City of Santa Fe, New Mexico

memo

2025-011538-HDRB, 800 Gildersleeve St., Don Gaspar Area Historic District, Contributing, Shane Woods and Gabe Rippel, owners, request approval for a 120 sq. ft. detached free-standing pergola to a height of 7'-8", where the maximum allowable is 15'-1".

Figure 1. Proposed Site Plan.

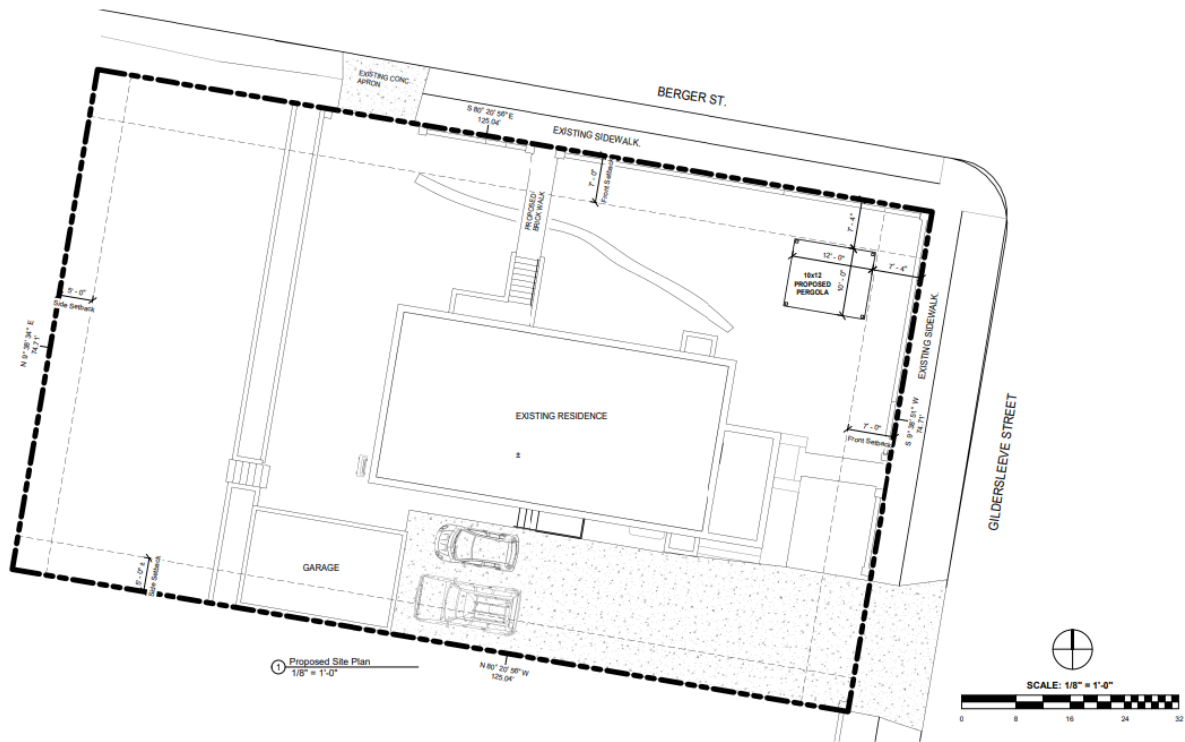
Staff recommends approval of the proposed project (with no roof structure) and finds that the application complies with Section 14-5.2(D) General Design Standards for all Historic Districts, and 14-5.2(H) Don Gaspar Area Design Standards.
